MCPB Item No 15 01-11-07

MEMORANDUM

Improvements To The Montgomery County Solid Waste Transfer Station

Mandatory Referral (Section 7-112 of the Regional District Act) -

EXHIBIT 2 – SITE PLAN

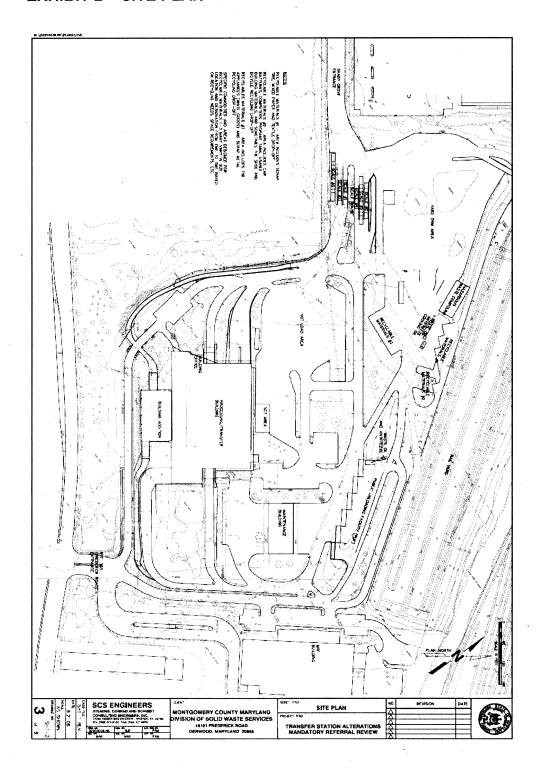
The proposed addition conforms to the Sector Plan recommendations. The new truck scales will alleviate potential vehicle and truck queuing onto Shady Grove Road. Further, additional landscaping along the front of the building and new road are consistent with the Plan's recommendations.

As previously noted, the height of the addition to the Transfer Building will be 44 feet as measured from the tip floor to the highest flat portion of the roof. According to the applicant the height of the addition will be the same height as the existing (adjoining) building. Section 59-C-5.3 stipulates the maximum height for buildings in an I-1 zone as 42 feet. The applicant's position on this issue is that the design height is a result of the need to accommodate the heavy commercial trucks unloading solid waste using hydraulic equipment that raise the cargo area of the trucks. There is also a need to accommodate HVAC and other infrastructure unique to this type of building.

Community Based Planning staff has reviewed this issue and believes that Section 59-C-5.41(b)(1) – Special Regulations for I-1 Zones could be considered as applicable in this instance. These special regulations are intended to encourage planned development of employment centers and allow for building heights of up to 120 feet. The Community Based Planning Staff memo is provided as Attachment C for reference. Staff supports the application of the Special Regulations in this instance in that (1) the existing building height of 44 feet is sufficiently distant from and buffered by screening so as to not impact residential properties and (2) the zoning and use of properties adjacent to the Solid Waste Transfer Station are not impacted by the proposed building height of 44 feet.

The addition to the Transfer Building will result in the building line being an estimated 85 feet closer to Frederick Road, or about 182 feet from the nearest northbound travel lane, compared to the existing distance of an estimated 267 feet. Internal vehicular traffic in the form of heavy commercial trucks traveling on the new internal roadway will be about 160 feet from the nearest northbound travel lane. These vehicles are currently operating over an internal roadway that is an estimated 400 feet from the Frederick Road and cannot currently be seen from Frederick Road. As

The most important aspect of this project from a safety perspective appears to staff to be the additional space on the tipping floor that will provide for: (1) better separation of heavy commercial vehicles from other vehicles and (2) more space for vehicular movements within the Transfer Building. According to the applicant, the enhancements in the scale house area will reduce waiting times by 33 percent and result in fewer instances were the trucks waiting to access the facility create a queue that extends onto Shady Grove Road. The Traffic Flow Plan submitted by the applicant includes a four way stop at the intersection of the new one-way internal circulation roadway and the existing two-way roadway that provides access to the office building. Pavement markings are noted in the plan as being consistent with MUTCD standards but there is no similar reference to the signing as being consistent. Staff recommends that this be clarified and that speed limit signs be posted in advance of the intersection with the existing roadway and immediately after exiting the Transfer Building. The posted speed should not exceed 25 mph on the new roadway.
